SERVICE TEST
of
XM200 2.75-INCH AIRCRAFT ROCKET
LAUNCHER

Final Report
by
LTC John O. Gilliland
October 1969

DEPARTMENT OF THE ARMY
UNITED STATES ARMY AVIATION TEST BOARD
Fort Rucker, Alabama 36360

SUBJECT: Final Reports, Engineering and Service Test, XM200 Rocket
Launcher for 2.75-Inch FPAR, USATECOM Project No.
4-ME-300-200-001/003

Figure 7. Rear view of XM200 showing wires damaged by rocket blast.

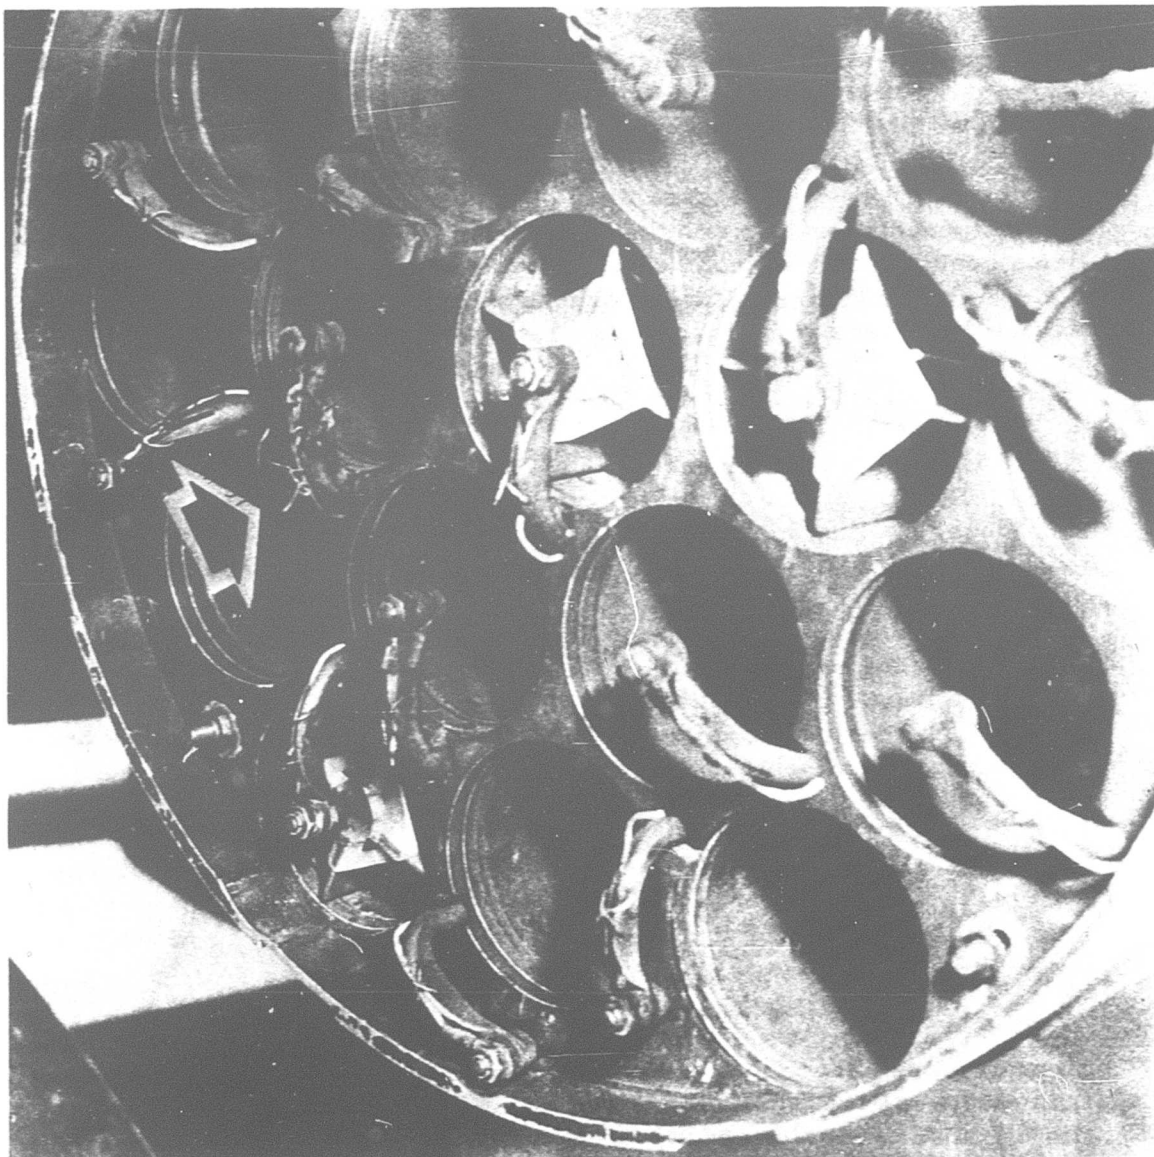
The electrical wires from the individual firing contacts to the aircraft quick-disconnect were routed through a channel in the launcher frame between the rocket tubes and around the supporting structure (fig 6). Due to lack of space, the insulation on the wires was easily pinched and/or damaged. In addition, the exposed wires at the electrical firing contacts were damaged from the rocket blast and deteriorated with use (fig 7). Stray voltage, electrical shorts, and misfires resulted from both conditions, thus requiring partial disassembly of the launcher for outside tubes and complete disassembly for the center tubes within the cluster to correct the situation. During reassembly of the launcher, the end play of the wires at the contact end allowed the wires to flex resulting in wires being bound between the tubes and launcher rear bulkhead again causing damage to the insulation. Stray voltage and electrical shorts were encountered after reassembly.

The small pin which locked the contact shaft in the clear or armed detent broke on numerous occasions. The shaft required rotating when loading, arming, and unloading a rocket from the tube. Wear on the pin was caused during this operation; however, the pins were broken when the rocket was launched. This was attributed to the rocket blast. The pin could not be replaced. The tube and contact assembly required replacing, thus requiring partial disassembly of the launcher for outside tubes and complete disassembly for center tubes to correct the problems.
